ADDENDUM NO. 1
TO
BIDDING AND CONTRACT
REQUIREMENTS AND SPECIFICATIONS
FOR THE
ROUTE 202A WATER MAIN EXTENSION AND WATER STORAGE TANK
WP PROJECT NO. 14206

8/18/2021

ROUTE 202A WATER MAIN EXTENSION AND WATER STORAGE TANK

ADDENDUM NO. 1

Attachment 8 – Antenna Support Assembly
Detail

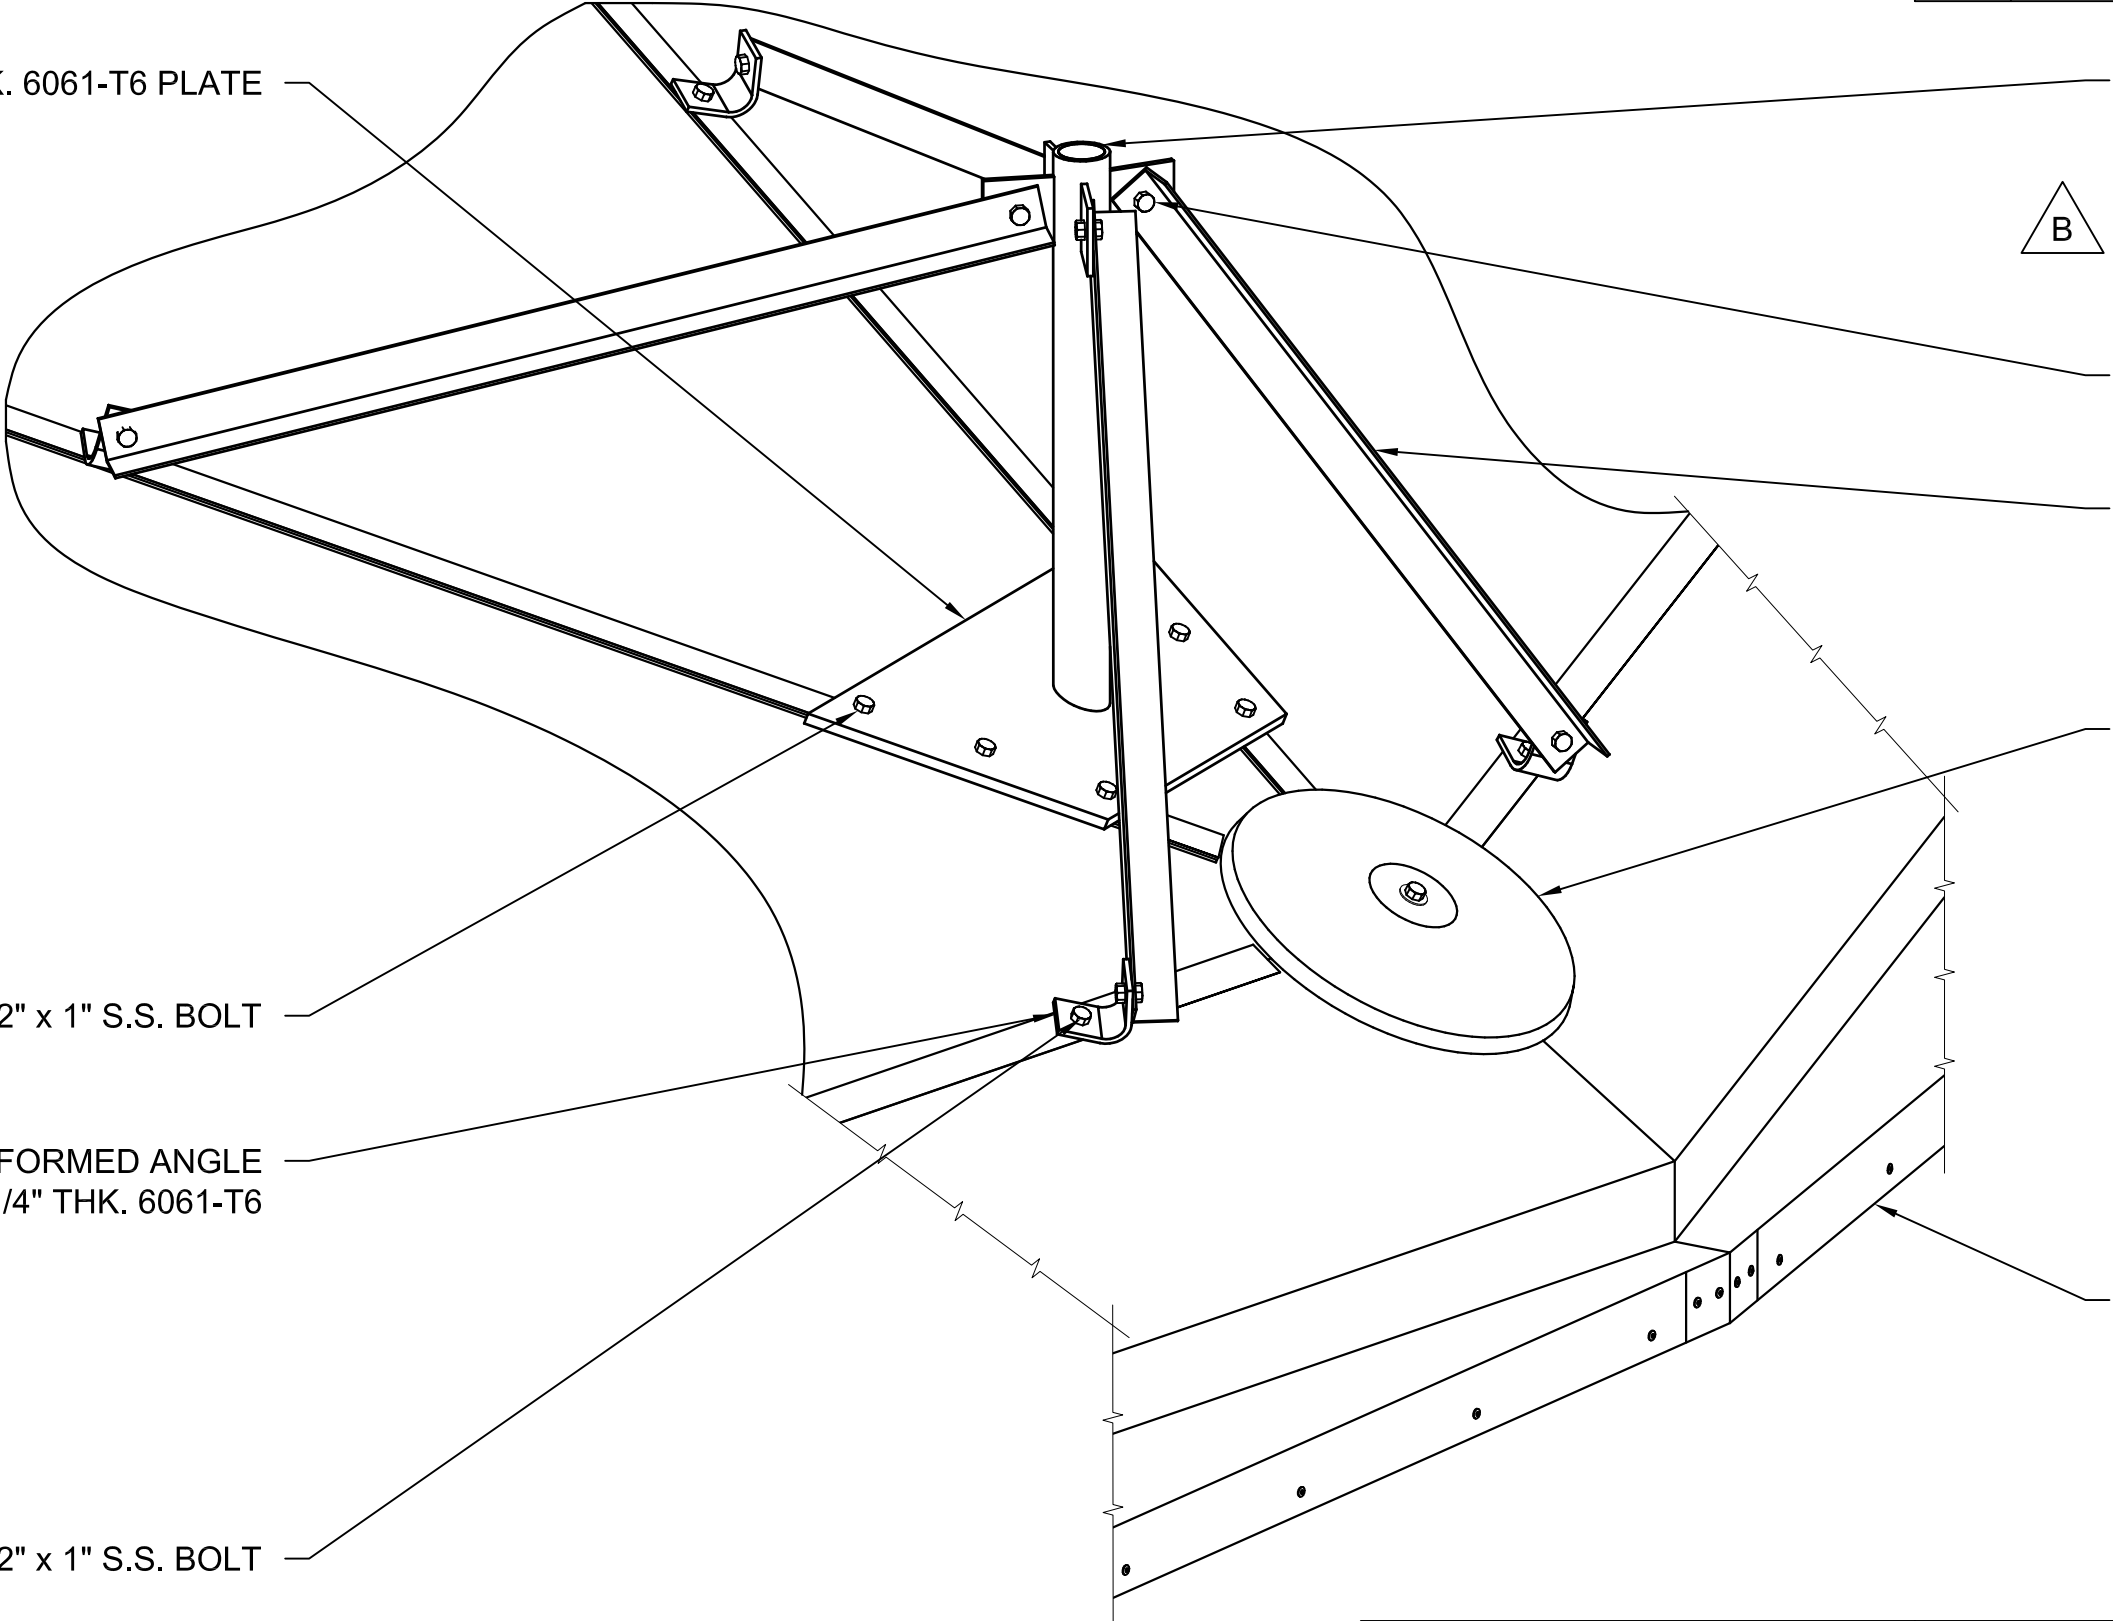
10. Drawing E-4, **ADD** detail titled “ANTENNA SUPPORT ASSEMBLY” attached to this addendum, as an alternative for radio antenna mounting on the water storage tank as shown in the detail titled “CONDUIT MOUNTING DETAIL FOR RADIO ANTENNA” (**Attachment 8**). Wiring, grounding, and applicable mounting as shown in “CONDUIT MOUNTING DETAIL FOR RADIO ANTENNA” will still apply as practical for use with alternative radio antenna mount.

ADDENDUM NO. 1
 REFERENCE: DWG C-5

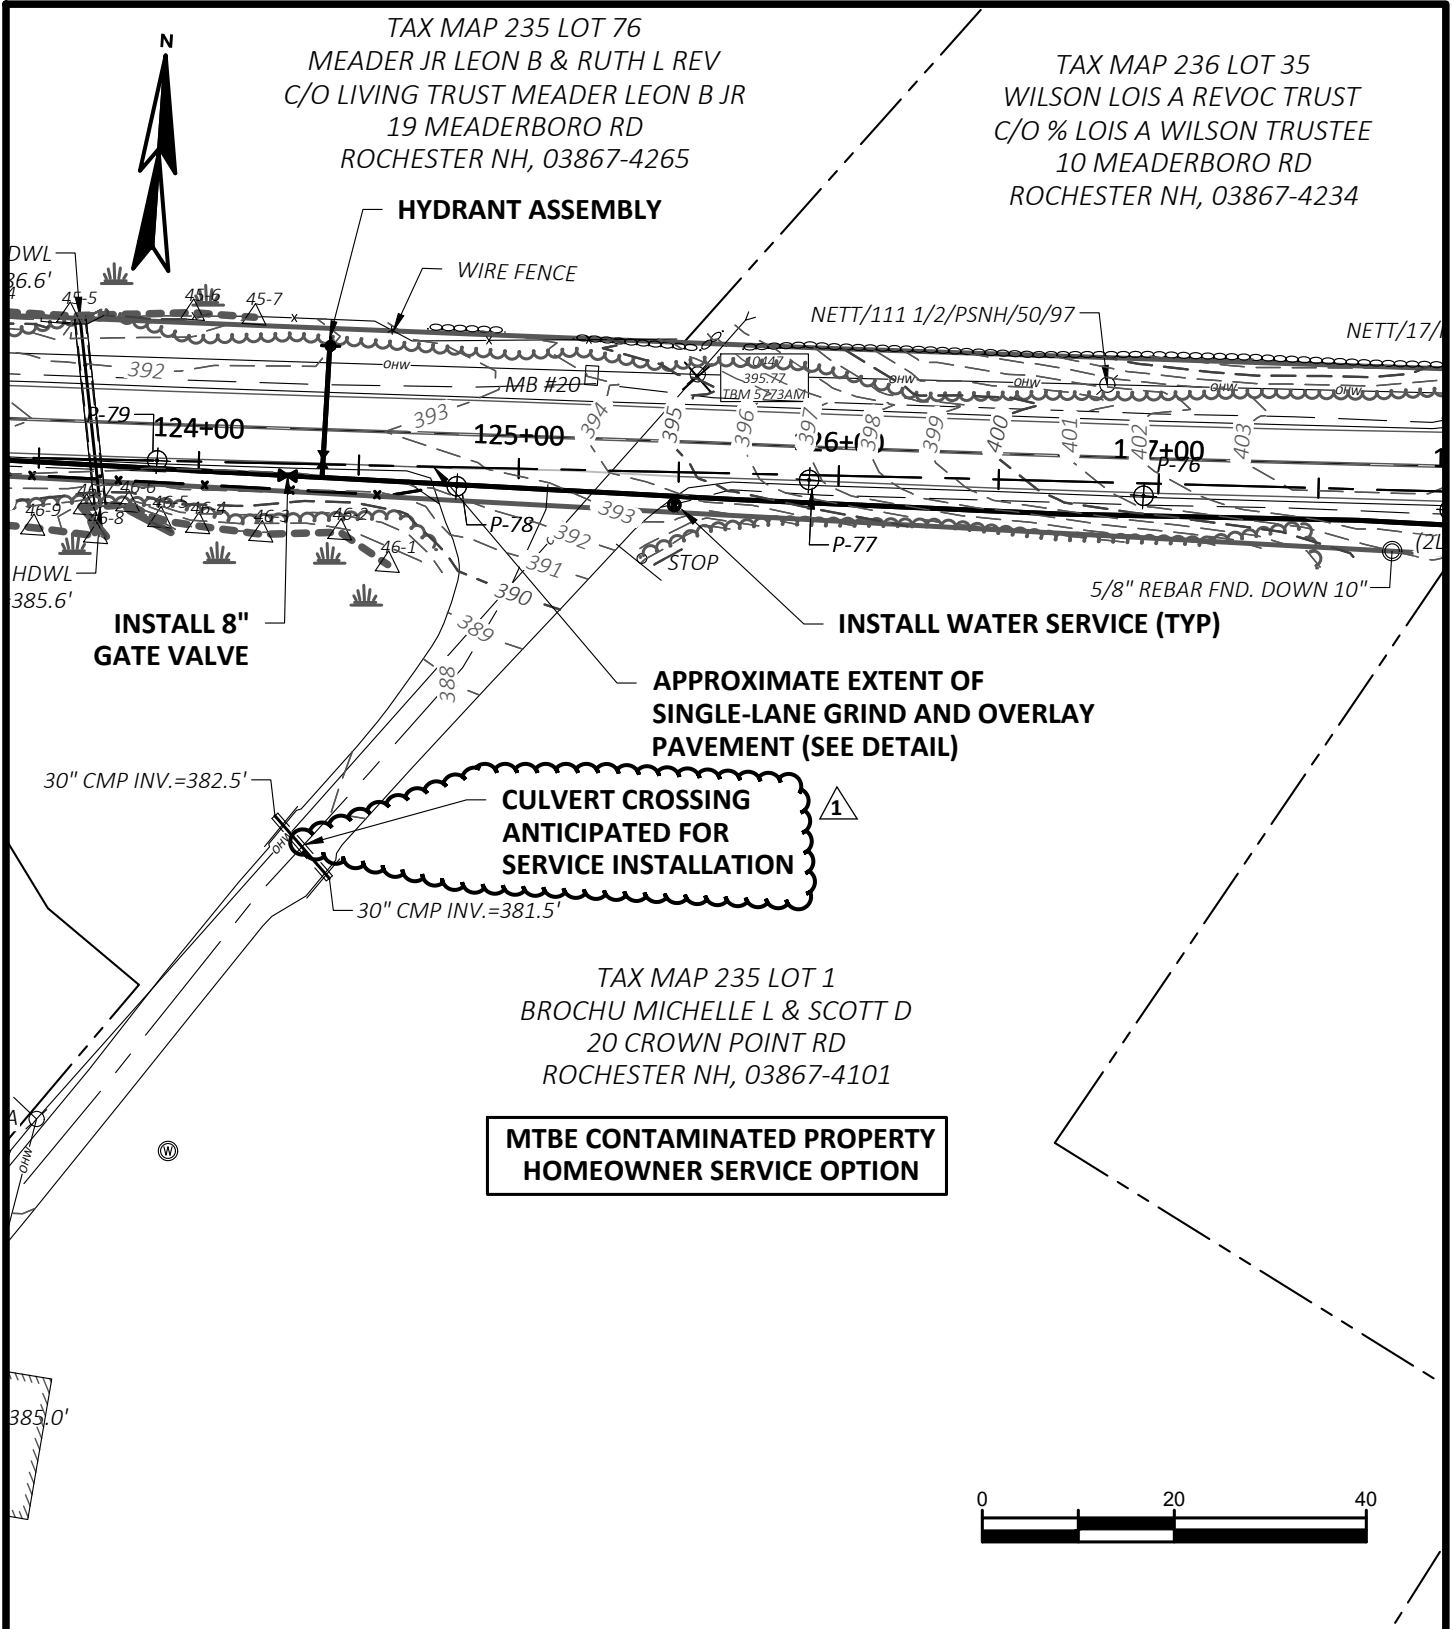
1. Drawing C-1, General Notes 2, under “Sewer/Storm Drain:”, **REPLACE** “JOHN ENGLAND” with “SCOTT MCGLYNN”.
2. Drawing C-5, **ADD** note “CULVERT CROSSING ANTICIPATED FOR SERVICE INSTALLATION” as shown on Figure 1, attached to this addendum (**Attachment 10**).

PAVED DRIVE APRON

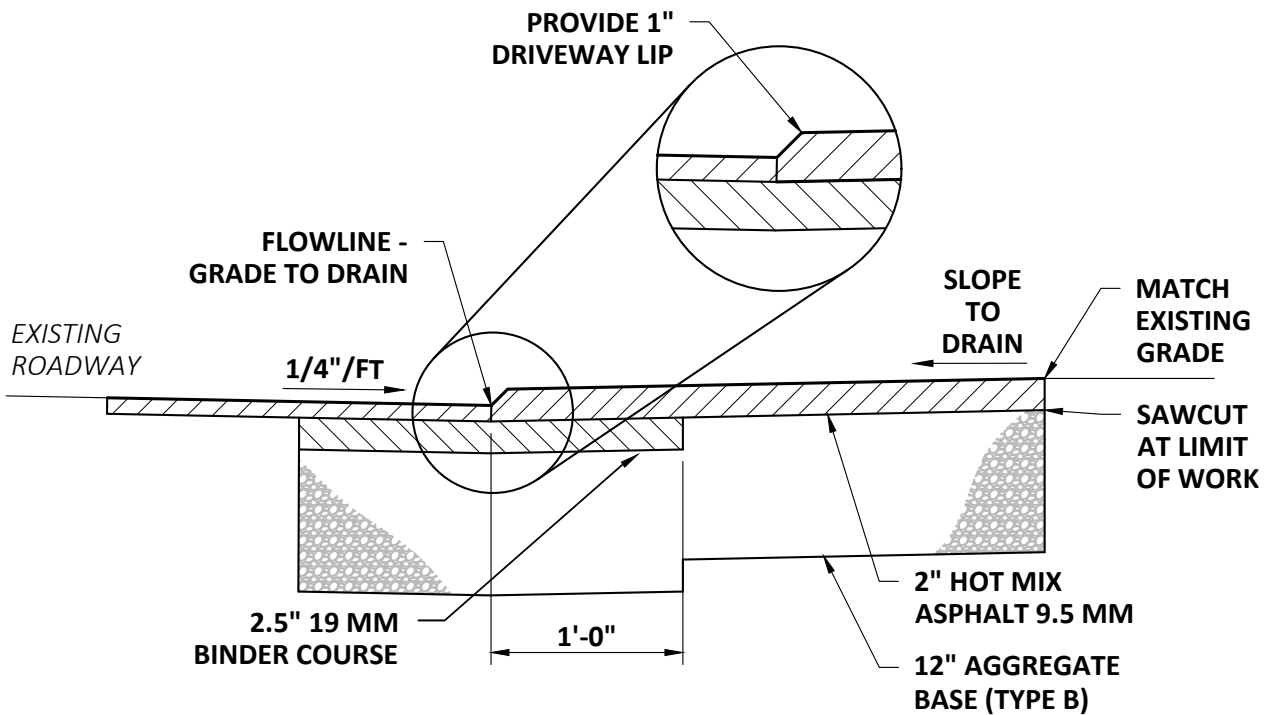
8. Drawing C-26, **REPLACE** detail titled “PAVED DRIVE APRON” with the detail in Figure 2, attached to this addendum (**Attachment 11**).
9. Drawing C-28, Note 2 under “STORAGE TANK NOTES”, **DELETE** “MANUFACTURER'S STRUCTURAL ENGINEER IS RESPONSIBLE FOR COORDINATION WITH OWNER'S GEOTECHNICAL ENGINEER ON APPLICABLE ELEMENTS OF STRUCTURAL DESIGN UTILIZING INFORMATION CONTAINED IN THE GEOTECHNICAL REPORT.”, and **REPLACE** with “MANUFACTURER'S STRUCTURAL ENGINEER IS RESPONSIBLE FOR COORDINATION OF ALL APPLICABLE ELEMENTS OF THE STRUCTURAL DESIGN UTILIZING INFORMATION CONTAINED IN THE GEOTECHNICAL REPORT.”

Attachment 13 – Figure 3

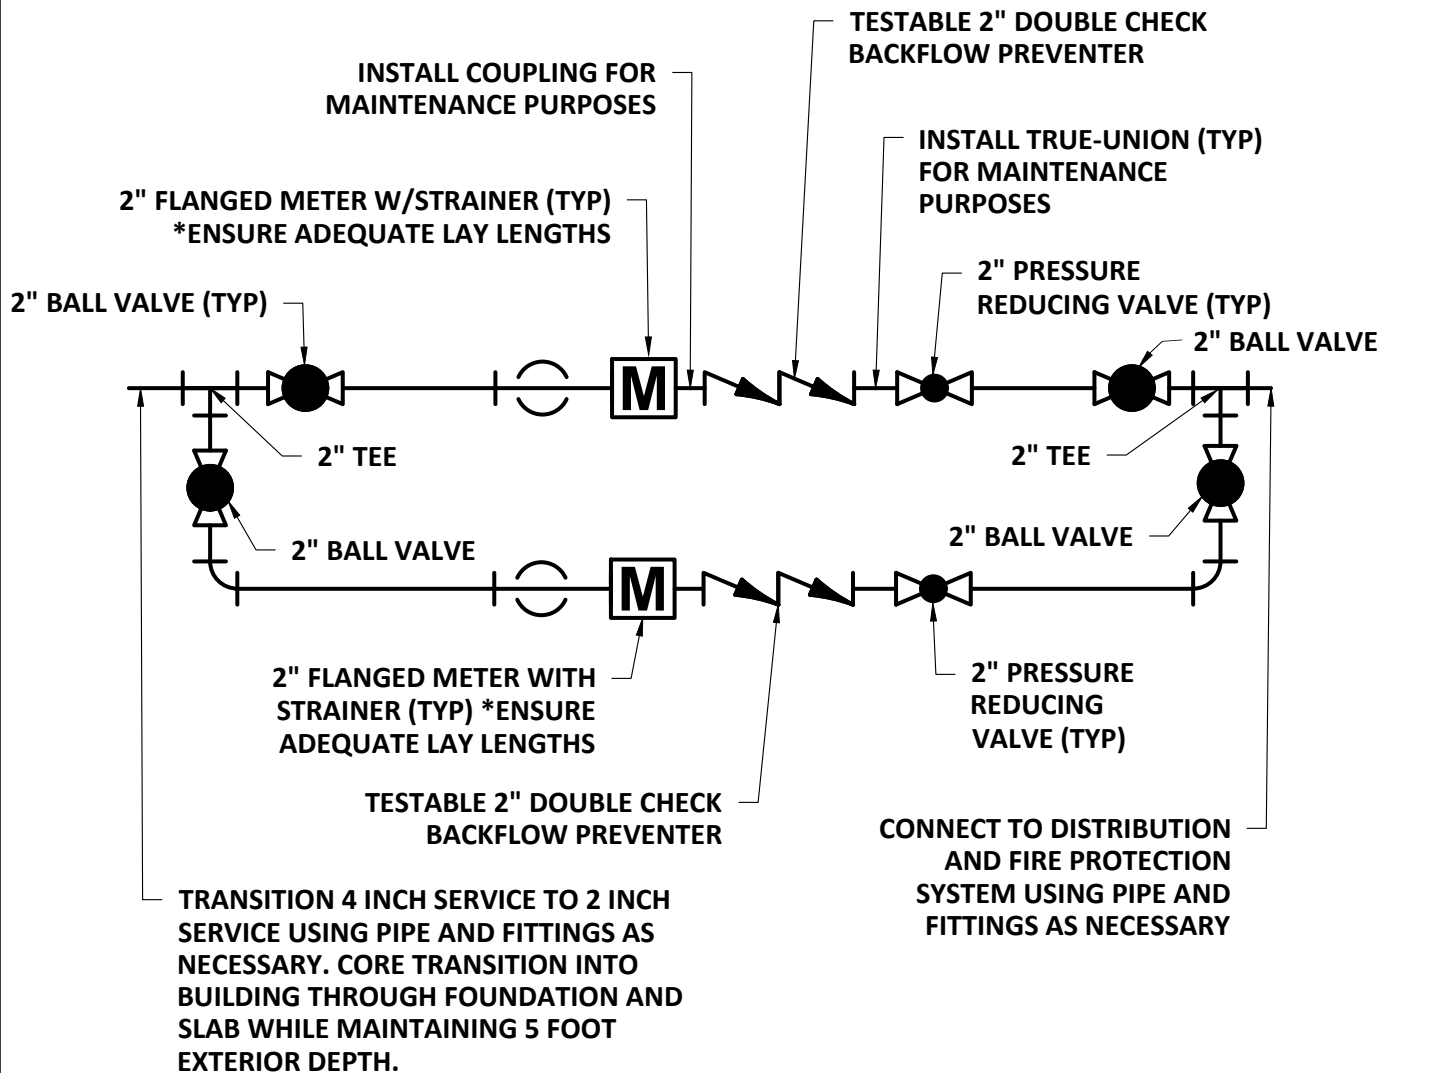
5. Drawing C-25 **DELETE** detail titled “TYPICAL CLEANOUT DETAIL”.
6. Drawing C-25 **DELETE** meter vault notes 1 through 4.
7. Drawing C-25 **ADD** detail titled “DUSTIN HOMESTEAD SPRINKLER ROOM CONNECTION SCHEMATIC” attached to this addendum as Figure 3 (**Attachment 13**).

1. CONTRACTOR TO DETERMINE REQUIRED LAY LENGTHS OF PIPE AND EQUIPMENT. FINAL DIMENSIONS TO BE APPROVED BY ENGINEER.
2. CONTRACTOR SHALL USE COPPER, STAINLESS STEEL, BRASS, OR APPROVED EQUAL MATERIAL FOR PIPES AND FITTINGS.
3. FLOW METERS SHALL BE SENSUS OMNI T2. THE CITY HAS STANDARDIZED ON THIS MODEL FLOW METER AND NO SUBSTITUTE WILL BE ACCEPTED. METER IS TO BE BATTERY POWERED.
4. INSTALL REMOTE READ EQUIPMENT IN CONDUIT FROM PRIMARY METER TO EXTERIOR OF BUILDING.
